## Modification or Addition to Improvement Standards and Details

Modification Number: 20080904-1

**ZONE 2 ELECTROLIER**  
(SERIES 'B')

DRAWING NUMBER  
**SL - 34**

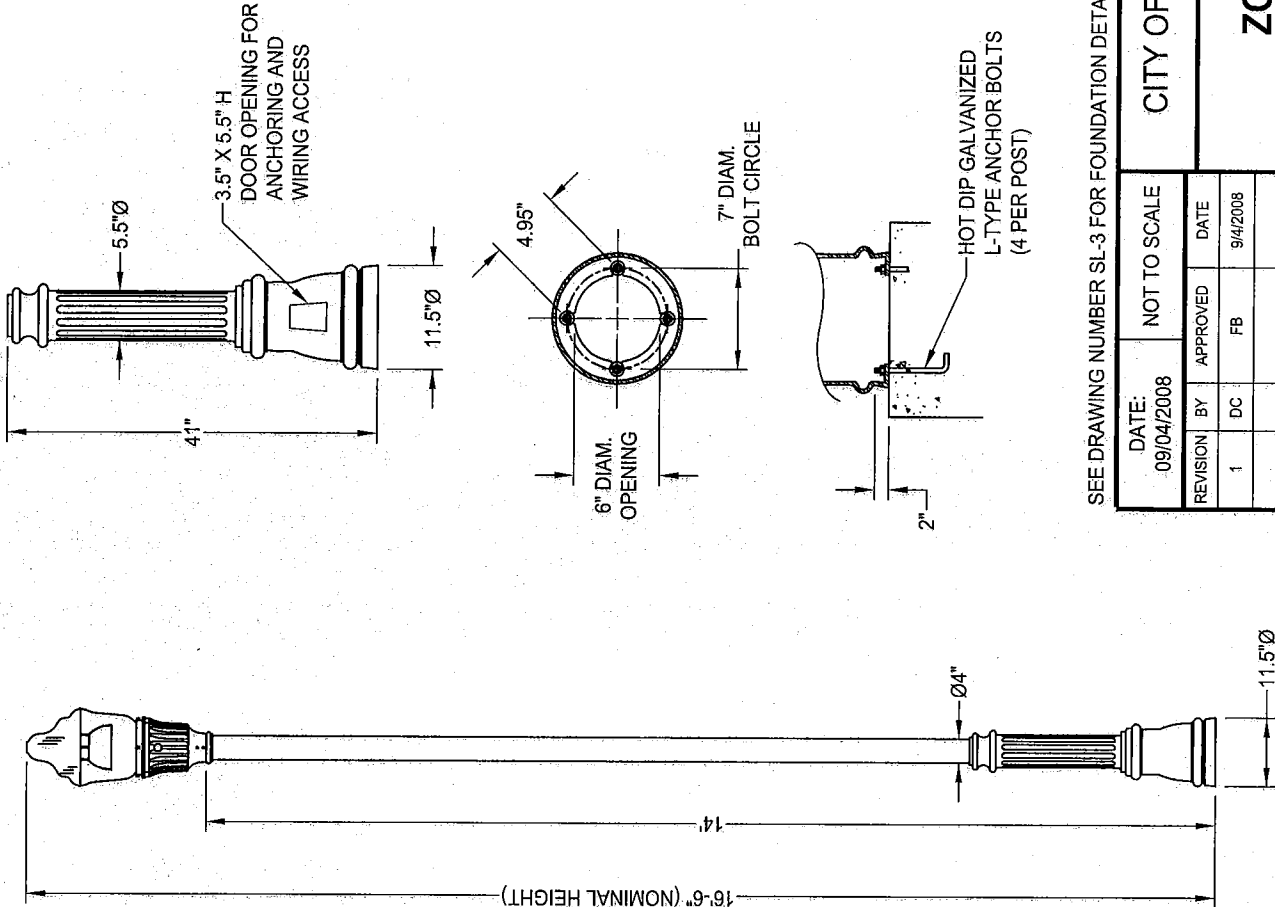
1. Modified Standard Drawing #SL34
  - Delete "No substitute will be considered. Contractor shall purchase exactly as specified and install."
  - Add "Approved Alternative...."

- This modification will allow another manufacturer to provide street light poles for the Zone 2 area.

**APPROVED ALTERNATIVE:**

THE CITY OF ELK GROVE MAY ACCEPT THE FOLLOWING AS AN ALTERNATIVE:

POLE: UNION METAL: DESIGN NO. P99-B360-Y1  
 FIXTURE: HADCO G63KLNZAFRG100SE  
 FINISH: BLACK POWDER COAT
